Subject: 10CFR21 Reporting of Defects and Non-Compliance -
Engine Systems, Inc. Report No. 10CFR21-0080

Agastat 7000 and E7000 series time delay relays applied in Woodward 2301A
low voltage circuitry

10CFR21 REPORTING OF DEFECTS
AND NON-COMPLIANCE

COMPONENT: Agastat 7000 and E7000 series relays

EXHIBIT 1

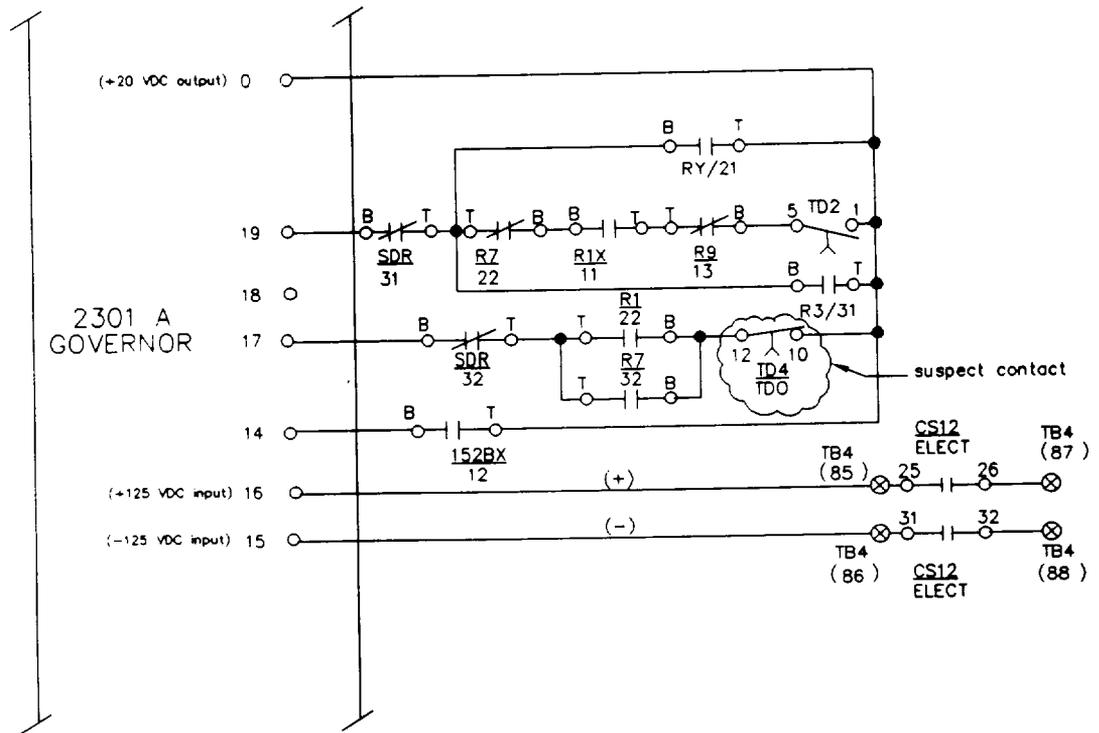
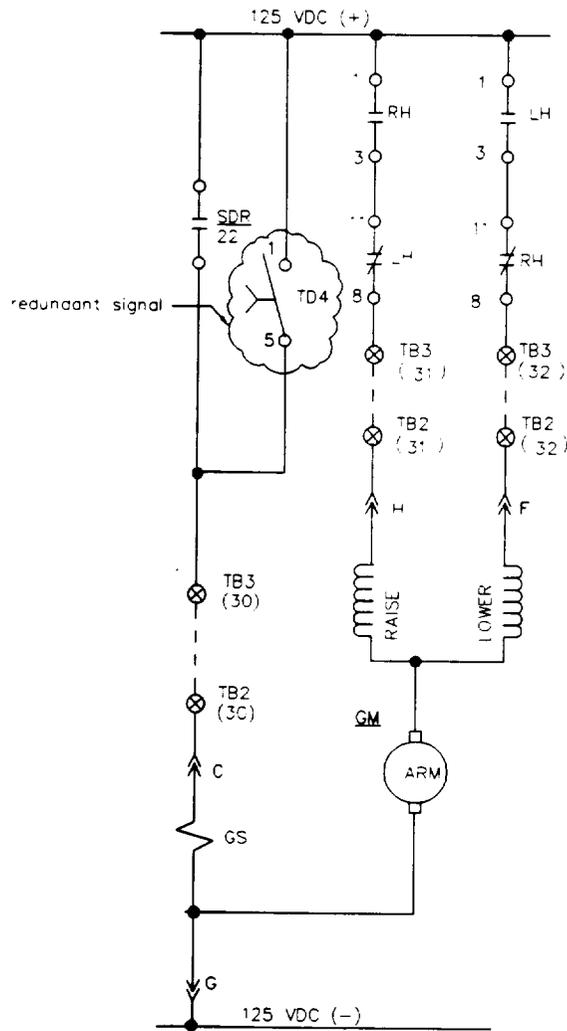
Terminal 17 is the 2301A "open for minimum fuel" input. A normally closed contact from the engine cooldown timer (designations TD4 or NST) opens to shutdown the engine after the cooldown period has elapsed. **Improper contact continuity (contact resistance greater than 1 ohm) could erroneously cause the 2301A to send a shutdown signal to the engine governor actuator during a safety event.**

Improper time delay relay contact continuity (contact resistance greater than 1 ohm) could activate the 2301A electronic governor "minimum fuel input" (shutdown) and there-by cause the diesel generator to fail-to-start or to shutdown during a safety event.

ESI recommends eliminating the suspect time delay relay contacts in the 2301A terminal 17 circuit. The diesel generators have a redundant shutdown feature via activation of the EGB governor actuator's shutdown solenoid; thus, both the 2301A and the EGB simultaneously receive a shutdown signal. The EGB shutdown signal is in a 125 VDC circuit and therefore contact continuity is not a concern in this application. Eliminating the contact in the 2301A shutdown circuit will remove the safety concern without affecting operation of the diesel generator.

The contact can be eliminated by removing the contact from the 2301A terminal 17 circuit or by simply placing a jumper across the contacts. Relay and contact designations for affected users are listed below:

<u>Customers</u>	<u>2301 term 17</u>
FP&L –Turkey Point #3:	NST contact 4-6
FP&L –Turkey Point #4:	TD4 contact 12-10
Wisc Elect - Pt. Beach G03/G04	TD4 contact 4-6
Knolls Atomic Power Labs	TD4 contact 4-6
KRSKO – Slovenia	TD4 contact 4-6
CFE Laguna Verde - Mexico	TD4 contact 4-6
